ADDENDUM NO. 1
TO
SPECIFICATIONS
FOR THE
GLOUCESTER CITY BOARD OF EDUCATION
CONTRACT #06 – MEDIA CENTER AND MAIN OFFICE ALTERATIONS
AT
GLOUCESTER CITY MIDDLE SCHOOL

Gloucester City Board of Education
1300 Market Street
Gloucester City, NJ 08030

LAN Job #2.20457.06
January 10, 2024

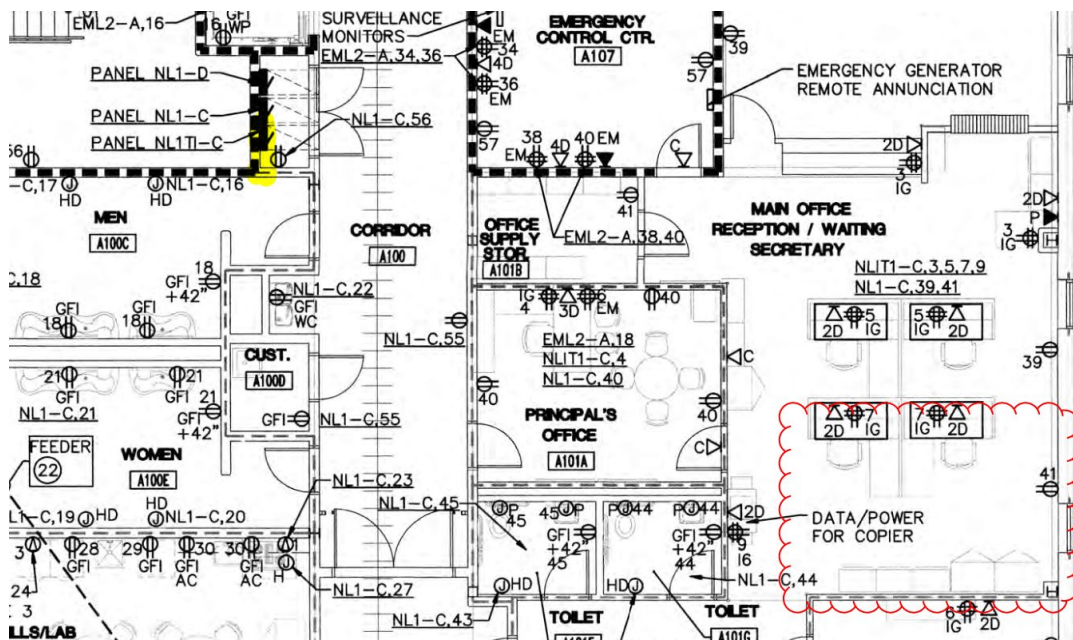
5.	<p>Q: Panel locations and distance for new circuitry:</p> <p>2nd Floor Circuits: PNL NL2-B #18 PNL NL1t2-B #25</p> <p>1st Floor Circuits: PNL NL1T1-C #19</p> <p>A: PNL NL2-B #18 – and PNL NL1t2-B #25 panels are located in Chiller Pump room A200E (see below). This room is accessed from the Roof area.</p>

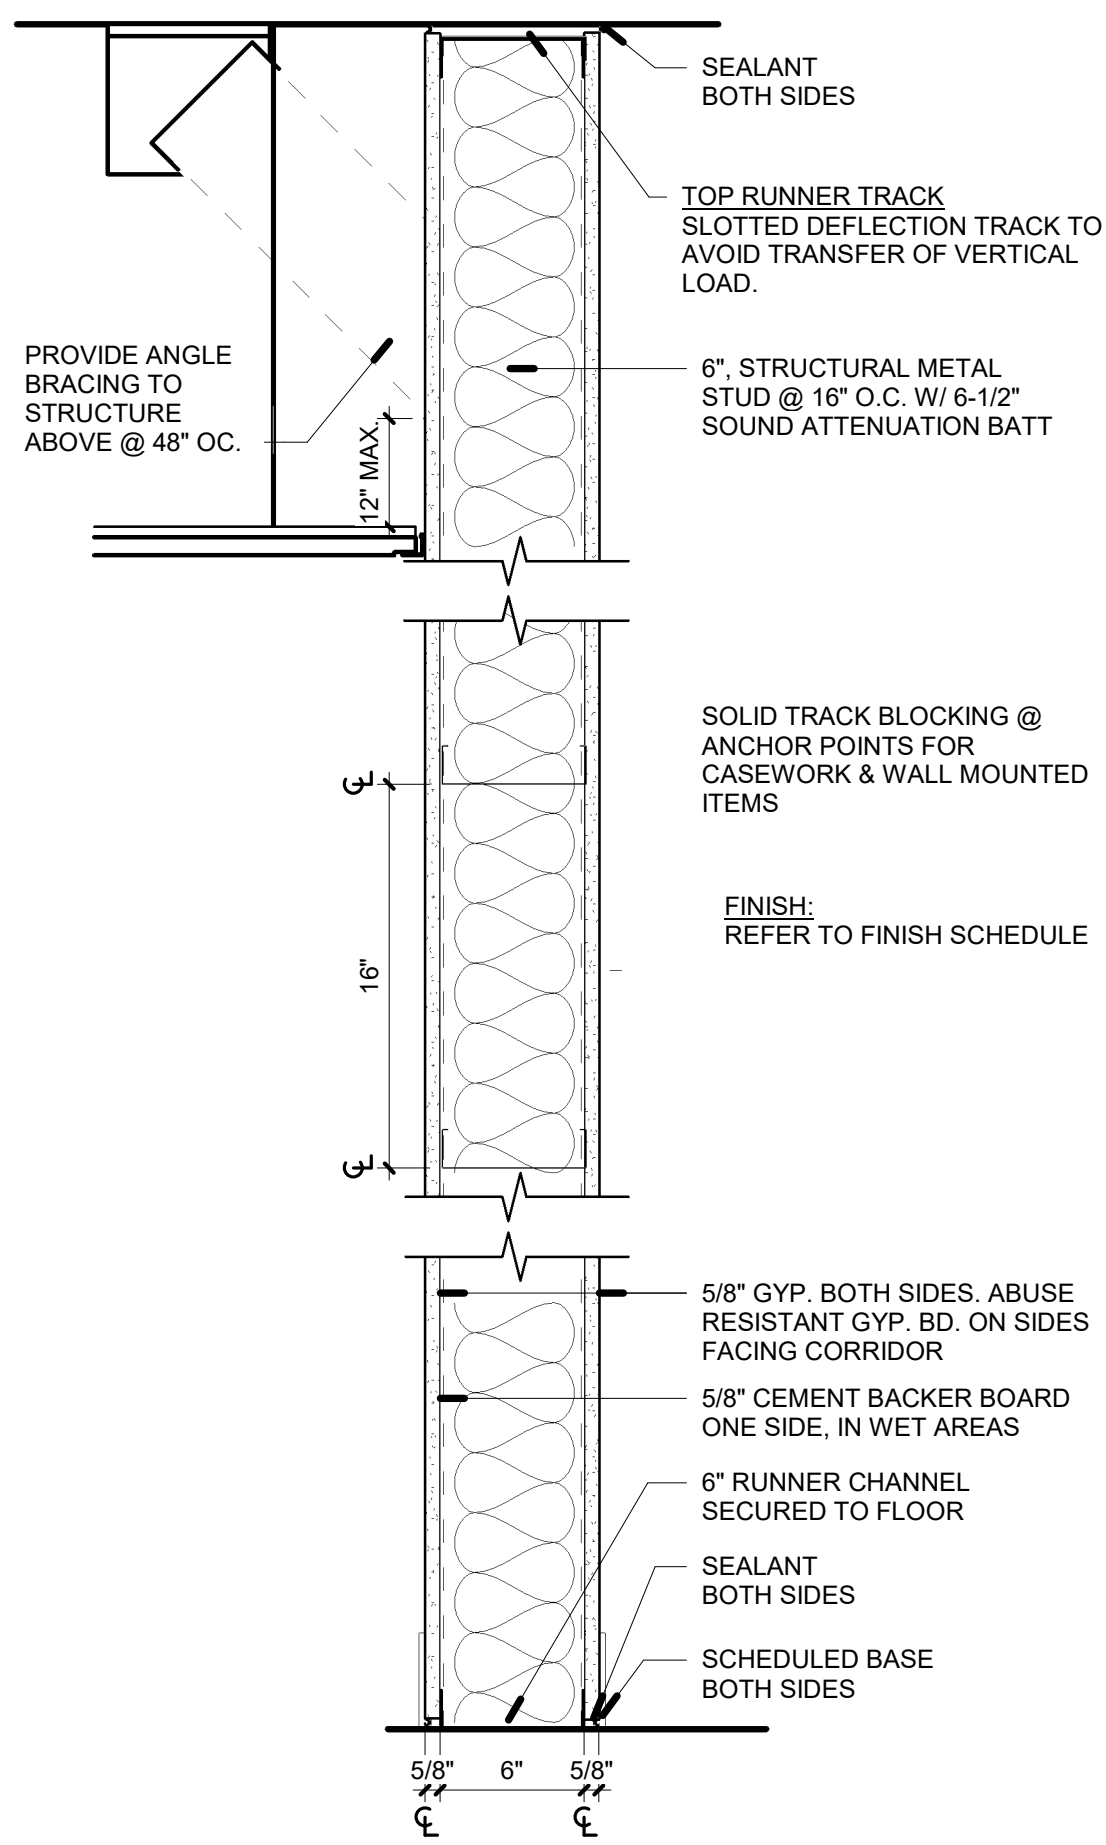
A: PNL NL1T1-C #19 - The panels are located in Electrical Closet across the Hallway (see below).

1 PARTITION TYPES
 T.03 1 1/2" = 1'-0"

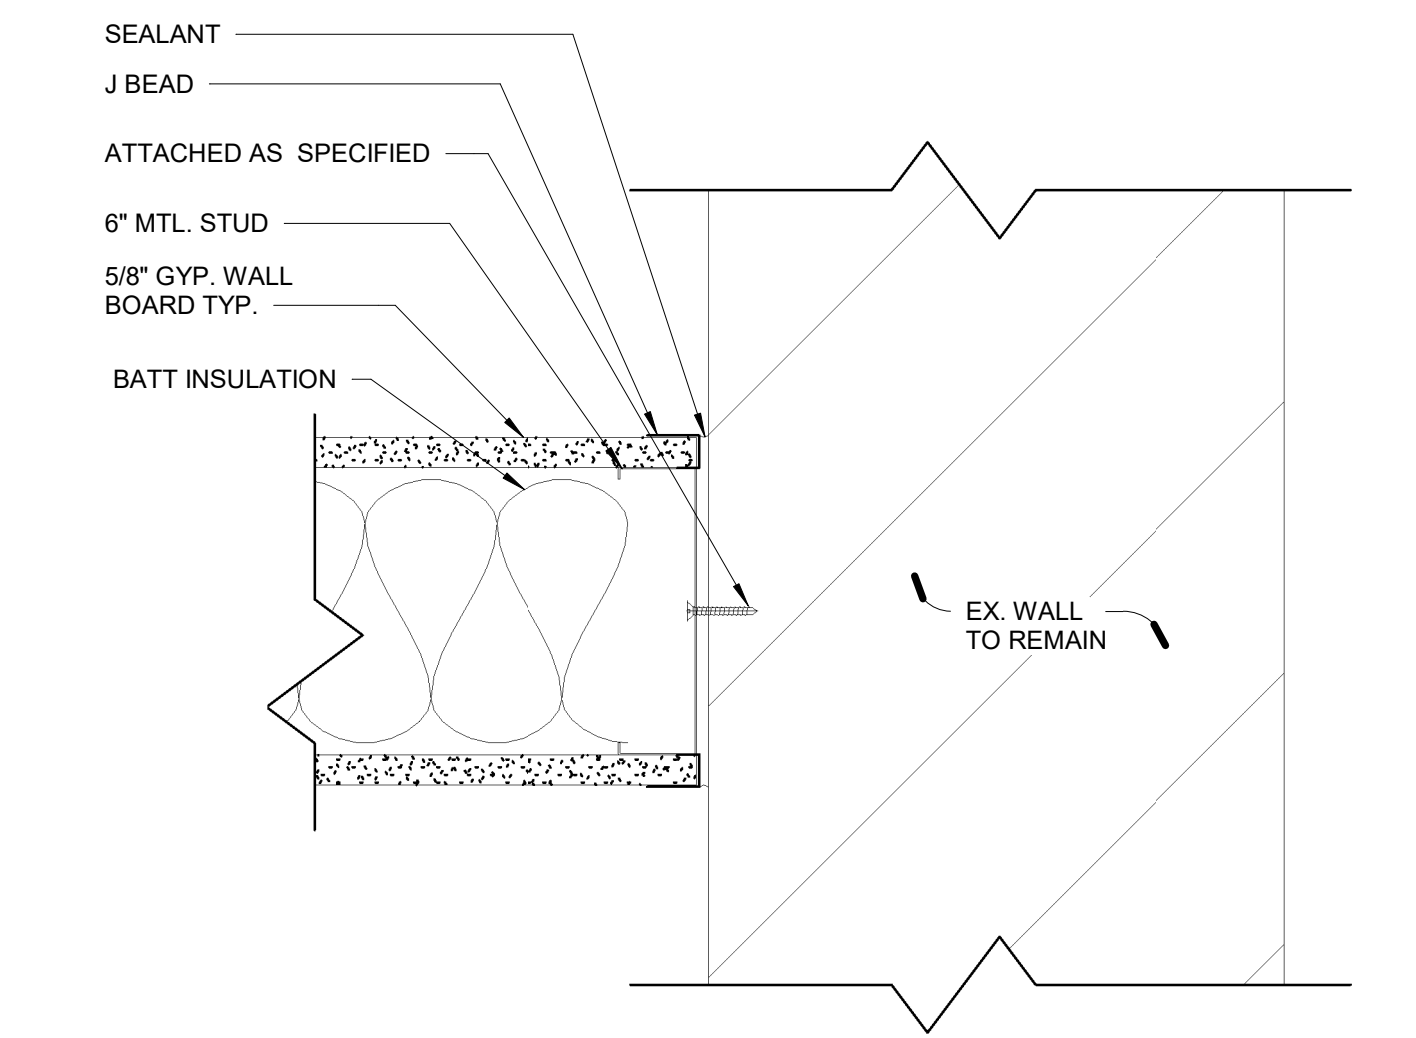
Dwg. No.	Addendum Requirements
T.01	ADD Sheet FP.01 'FIRE PROTECTION PLAN' to Drawing Index.
T.03	Detail 1: Refer to attached ENCLOSURE #1, Drawing Sheet T.03 'WALL TYPES' for revised partition type detail.
A1.01	Detail 5 ADDED to ENCLOSURE #2, Drawing Sheet A1.01 'DEMOLITION PLAN'
A1.01	Detail 2: REVISED to show locations of existing sprinkler head and the locations of heads to be removed and relocated.
A1.01	Detail 4: REVISED to show the locations of the existing sprinkler head and the locations of heads to be removed and relocated.
A2.01	Finish schedule has been REVISED. Refer to Question #08 of Addendum.
A2.01	Detail 2: 1 st Floor Proposed RCP REVISED to show the locations of the existing sprinkler and new pendent locations.
A2.01	Detail 4: 2 nd Floor Proposed RCP REVISED to show the locations of the existing sprinkler and new pendent locations.
A6.01	Refer to ENCLOSURE #4, Drawing Sheet A6.01 'DOOR SCHEDULE, DOOR TYPES & DETAILS' for REVISED door schedule.

1 1ST FLOOR DEMOLITION PLAN
A1.01 1/8" = 1'-0"

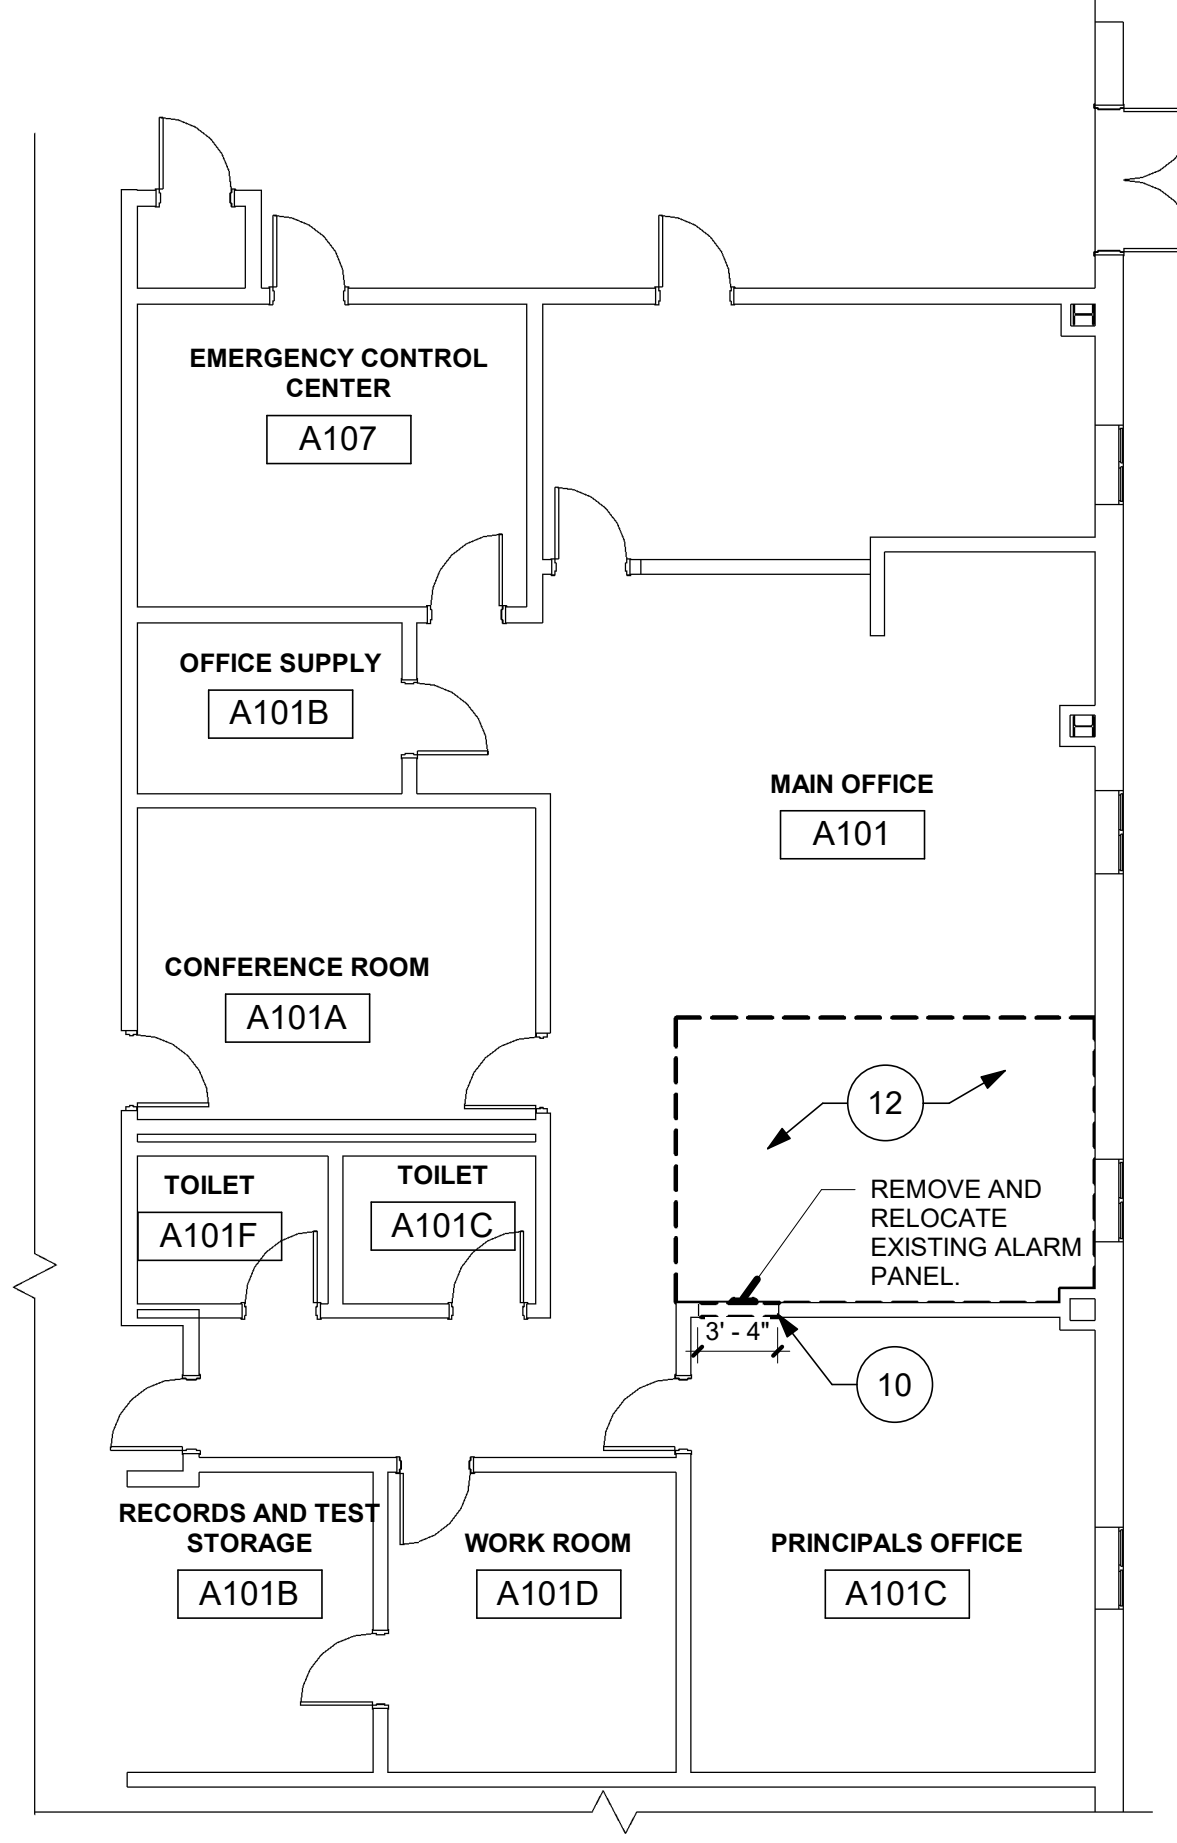
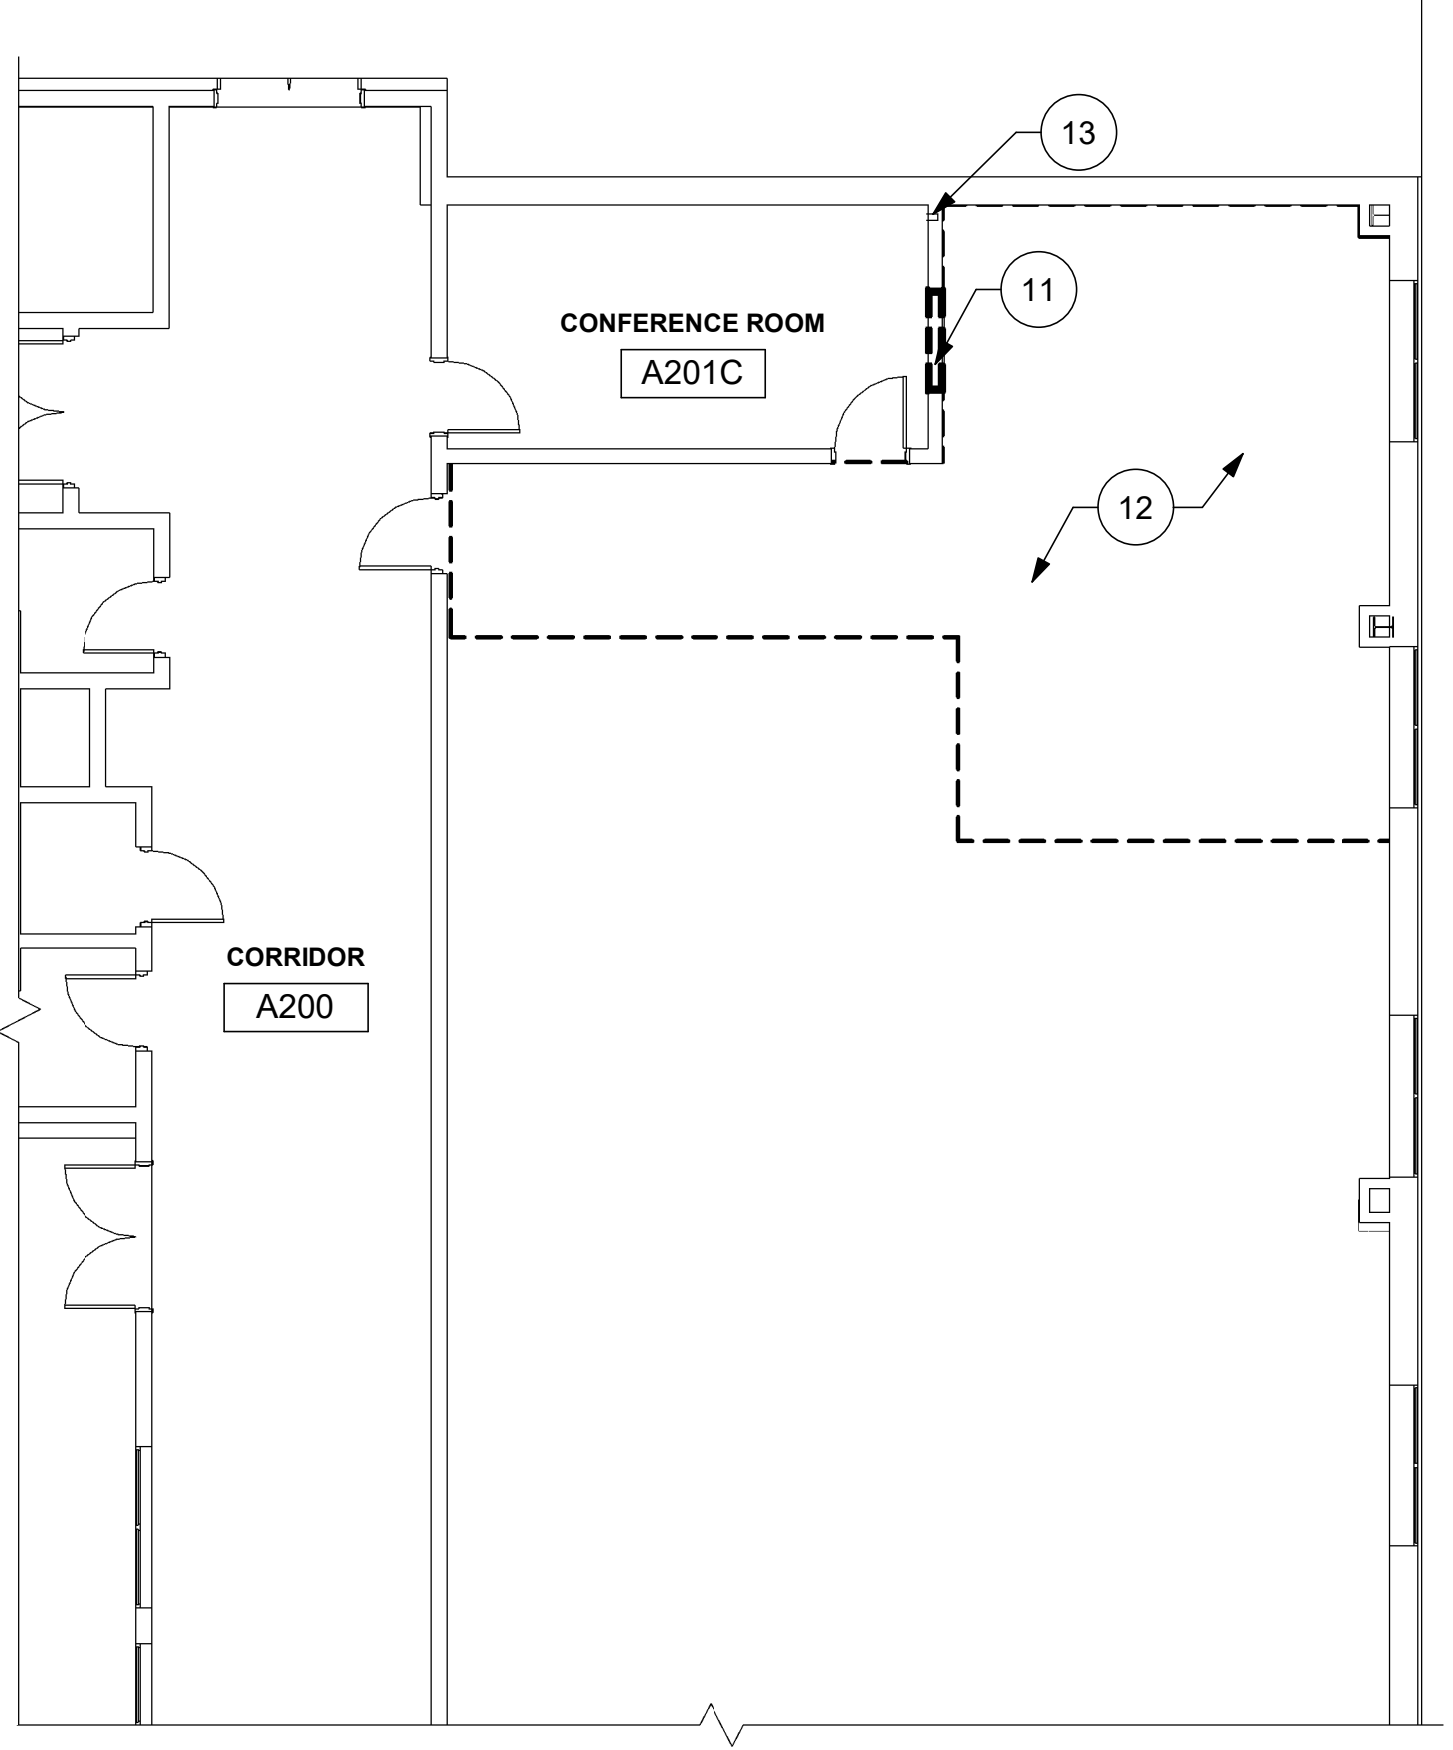
7. Q: On A1.01, it tells us to remove sprinkler heads. I do not see new heads on the new RCP. Are we only demolishing the heads, or do they need to be reconfigured for the new layout?
